## Executive Director's Recommendation

<b>PROJECT</b> <b>Southern Expansion and U.S. Air Force Memorial Modification</b> Arlington National Cemetery Arlington, Virginia	<b>NCPC FILE NUMBER</b> 8009
<b>SUBMITTED BY</b> United States Department of Defense United States Army Corps of Engineers	<b>NCPC MAP FILE NUMBER</b> 1.61(00.00)45214
<b>REVIEW AUTHORITY</b> Federal Projects in the Environs per 40 U.S.C. § 8722(b)(1)	<b>APPLICANT'S REQUEST</b> Approval of preliminary and final site and building plans
	<b>PROPOSED ACTION</b> Approve preliminary and final site and building plans with comments
	<b>ACTION ITEM TYPE</b> Staff Presentation

# Arlington National Cemetery Southern Expansion and Air Force Memorial Modification Project

Approval of Preliminary and Final Site and Building Plans

# Design Evolution – Vehicular Routes

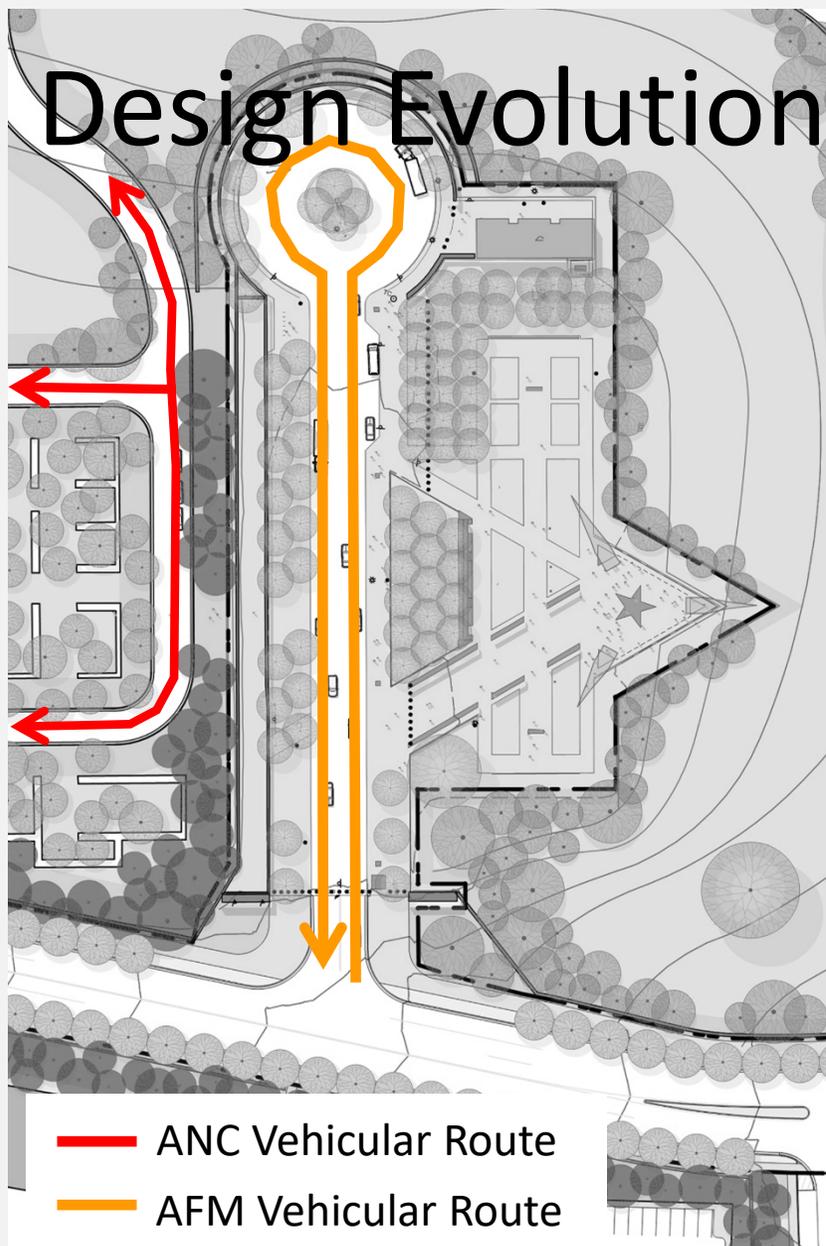
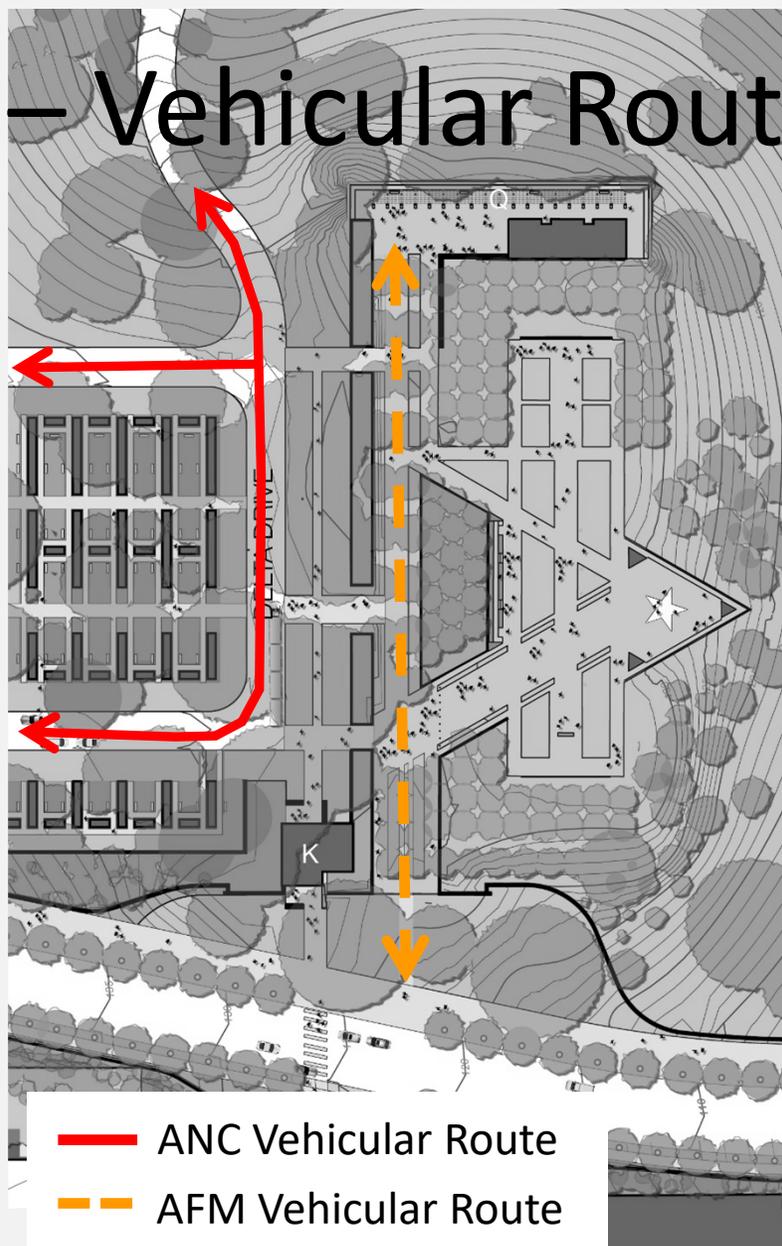
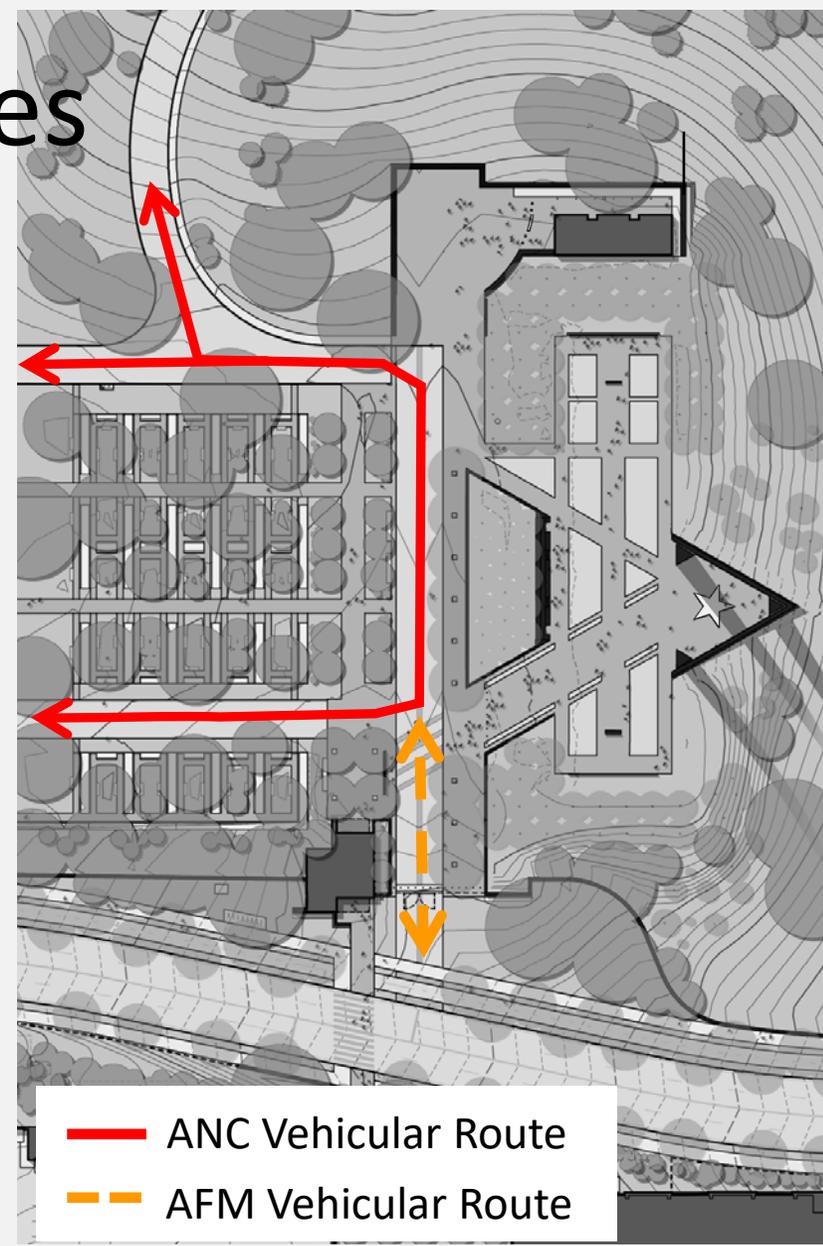
Recommends that USACE create either a design element or wayfinding or both that helps to provide a sense of arrival and guidance for visitors to the cemetery or the memorial.

**Staff Response** – USACE notes they collaborated with Air Force District Washington (AFDW) in developing a more integrated design by removing a roadway proposed in the concept design, Delta Road, and using the existing Air Force Memorial Drive as part of the cemetery’s internal roadway network. Staff is very supportive of this design change because it removes a duplicative roadway, which simplifies the overall design.

## Operation Center and Columbarium

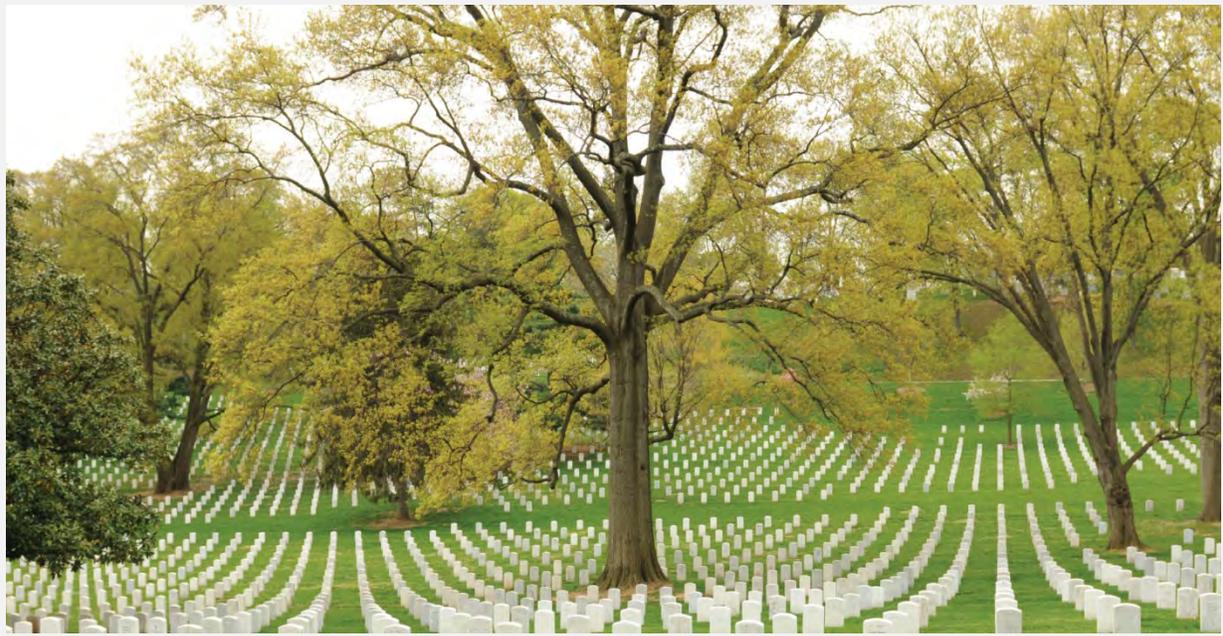
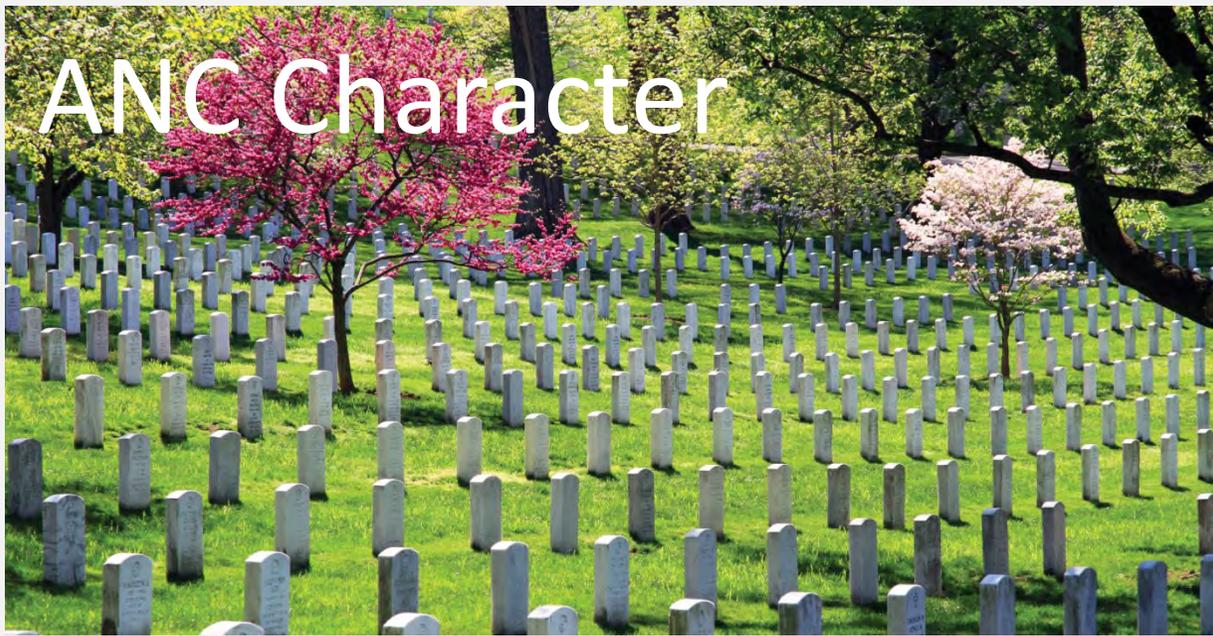
**Requests** the USACE develop site sections through the columbarium area, both east/west and north south, to understand the grade changes in this area more fully. In addition, sections through the in-ground burial areas and through the Air Force Memorial would also be helpful in understanding the visibility of and access to these areas.

**Staff Response** – *The USACE will alter existing topography as part of this project by creating landforms east and north of the Air Force Memorial for in-ground burials. Creating these landforms is only possible because USACE is also proposing to remove soil located west of the memorial, from the old Navy Annex site. The effect of this earthwork will lower the columbarium level to the same existing level as the memorial. Staff finds the new sections and perspective renderings provide a clearer understanding of the project. The USACE also provided additional drawings for the Operations Center which will be constructed partially below grade and buffered with landscaping. Staff is supportive of the design.*
